has permission to Construct 2424 s.f. Single family dwelling w/2 car garage

AT 36-38 Yale St (Lot #2 University Park)

RE: 36-38 Yale Street (lot #2 University Park) – 436-A-012 & 1/2 of 13 – R-3 Zone  
Permit application #03-0894

**Project No.** 36-38 Yale Street

# SCHEMATIC GARAGE SECTION

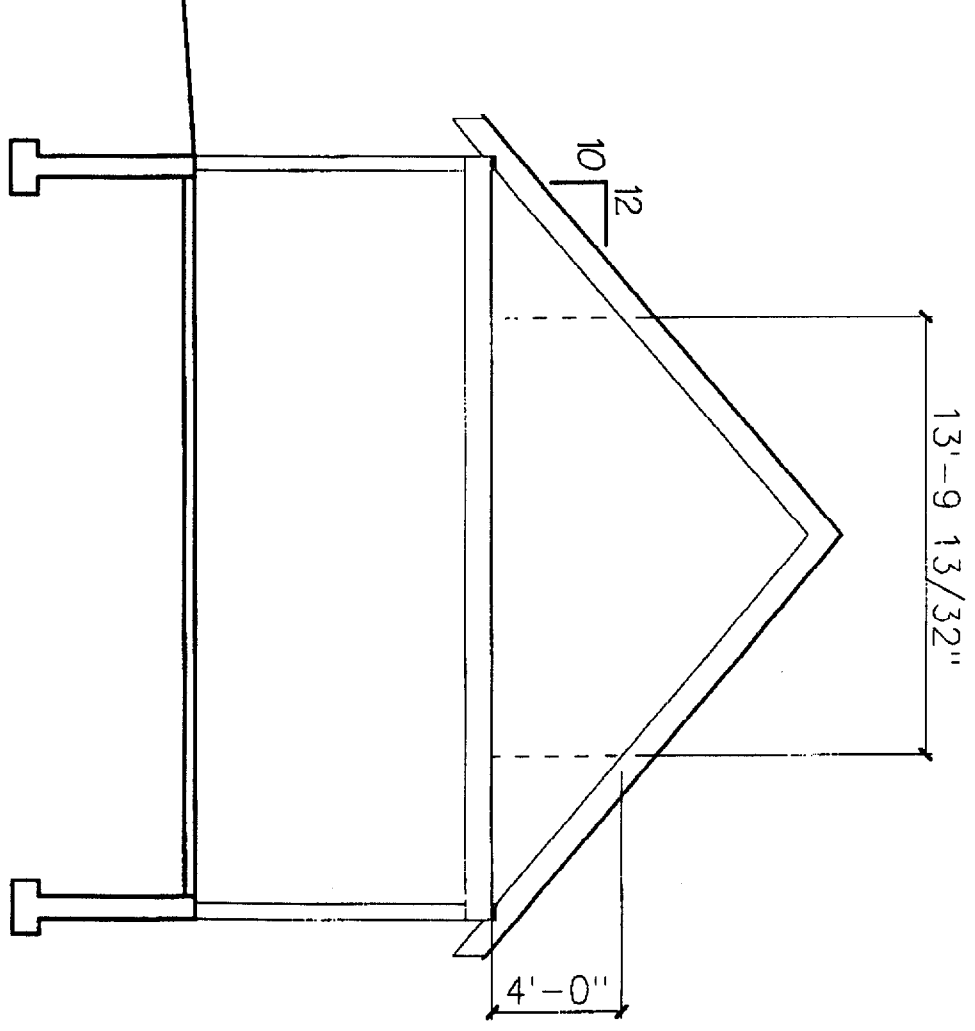
In order to revise the 1/2 story "Bonus Room" over the garage, I will need clarification on these points of the code:

- 1) Is the AREA of the 1/2 story measured \*only\* within an occupied space, or does it include unoccupied space?
- 2) Is the AREA of the 1/2 story calculated by measuring 'gross', to the outside of walls, or 'net' to the inside of the walls?
- 3) Is the story below calculated by measuring 'gross', to the outside of walls, or 'net' to the inside of the walls?
- 4) Is the 4'-0" height measurement taken from the top of floor sheathing to the underside of the structure, or from top of floor sheathing to the top of the roof sheathing?

Clearly, all of the initial discussions assumed that the interior of the finished space was the only area to be counted. If this does not hold true, then in order to maintain the architectural integrity of the dormer design, we will have to lower the roof pitch from 12/12 to 12/9.

Comments: The area measured is from the 4' height per the ordinance definition - If on the Garage floor plan that was original submitted, the walls are at the 4' level (I thought you said differently during our <sup>last</sup> phone conversation) and there is no dormer, then your proposal would work.  
Please confirm - Marge

**COND FLOOR PLAN**

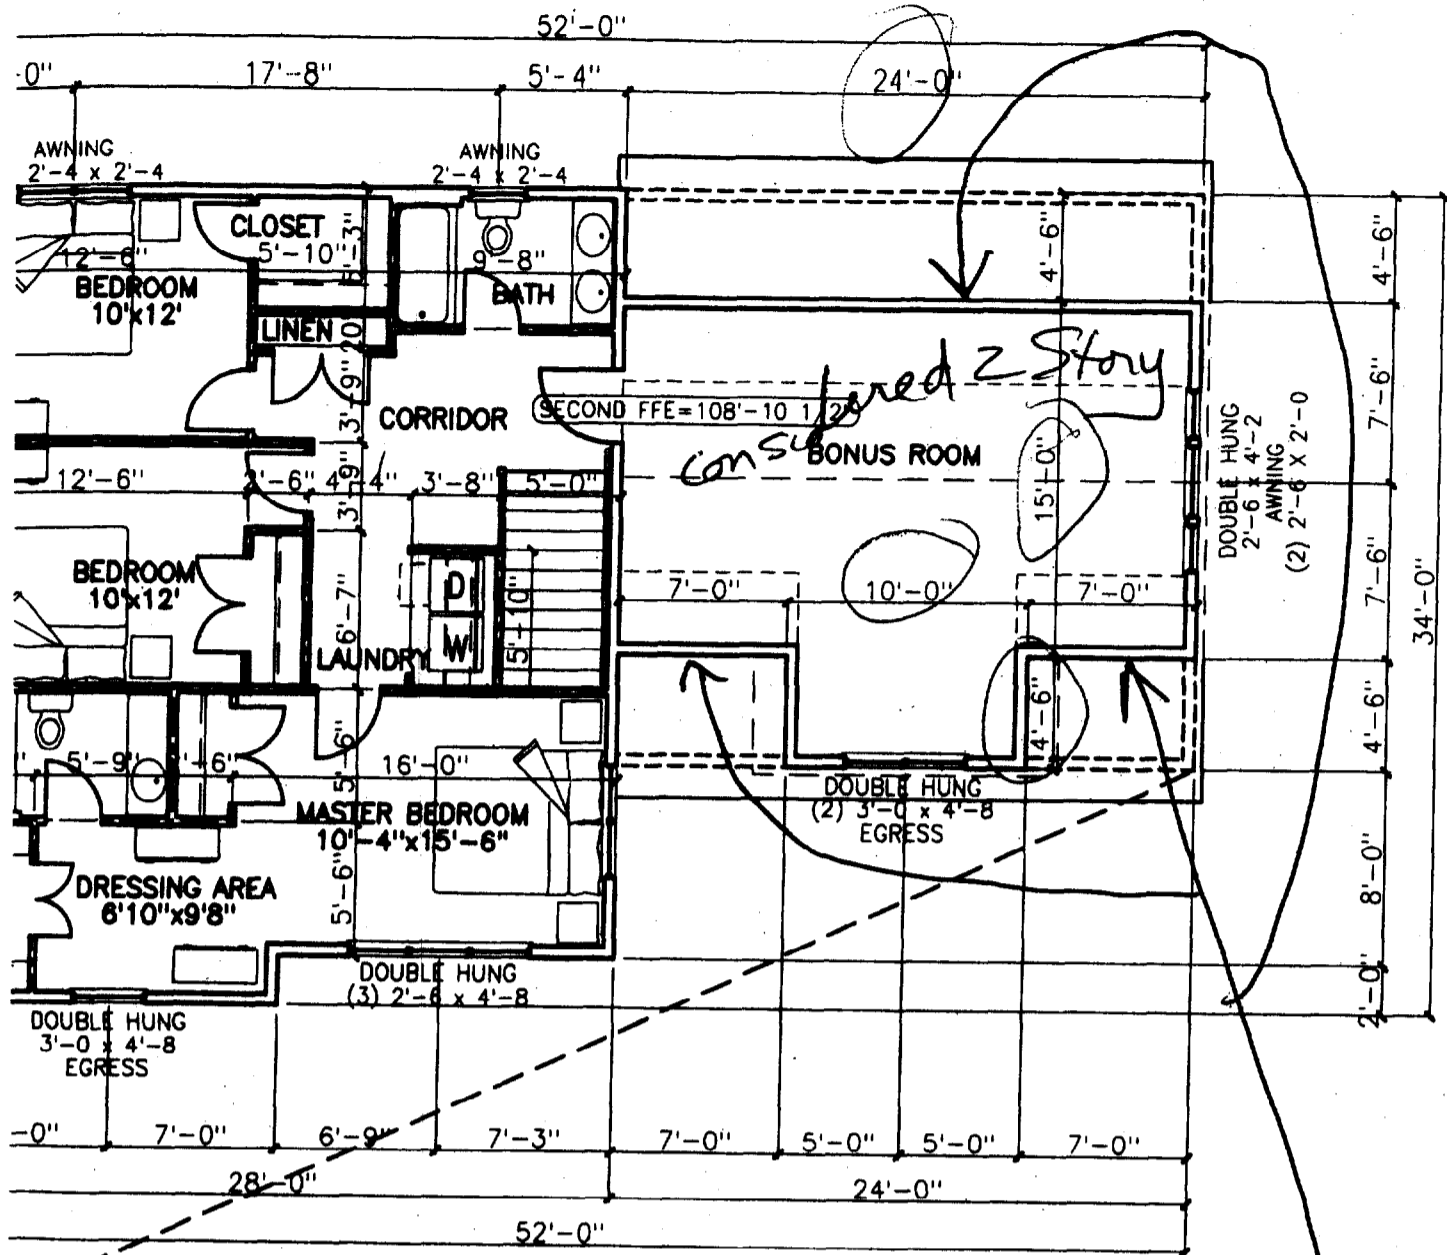
$$24 \times 24 = 576 \text{ sq ft} \times .66 = 380.16 \text{ sq ft} \text{ MAX on 2<sup>nd</sup> floor}$$

$$405 \text{ sq ft}$$

over  
considered 2 stories

Are you saying  
That these walls  
are at the 4th  
level?

Are you suggesting  
NO windows?  
doorway? SCHEMATIC GARAGE SECTION

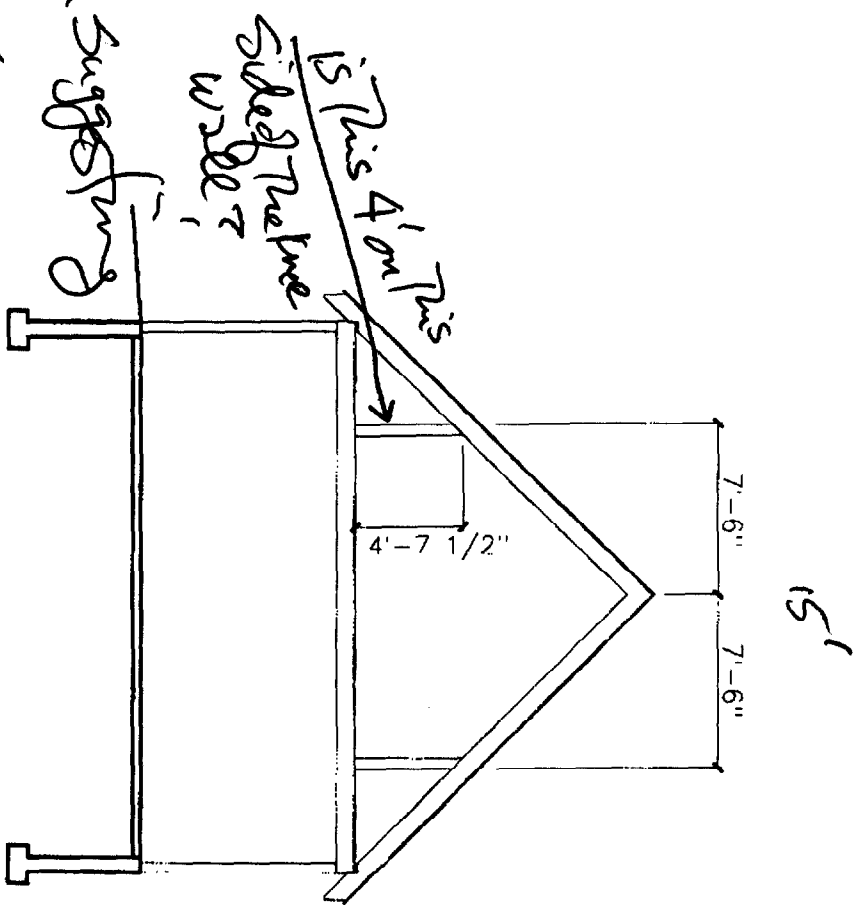
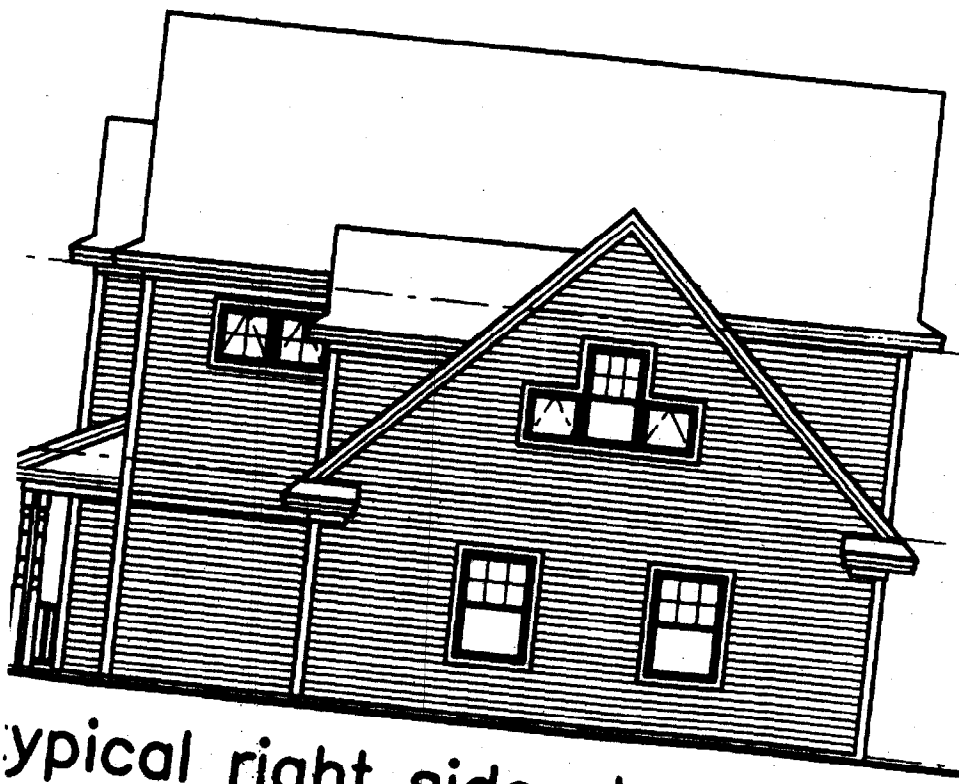
$24 \times 24 = 576 \text{ sq ft} \times 0.66 = 380.16 \text{ sq ft}$  MAX on 2<sup>nd</sup> floor  
to use 1/2 story setbacks

$405 \text{ sq ft}$

considered 2 stories
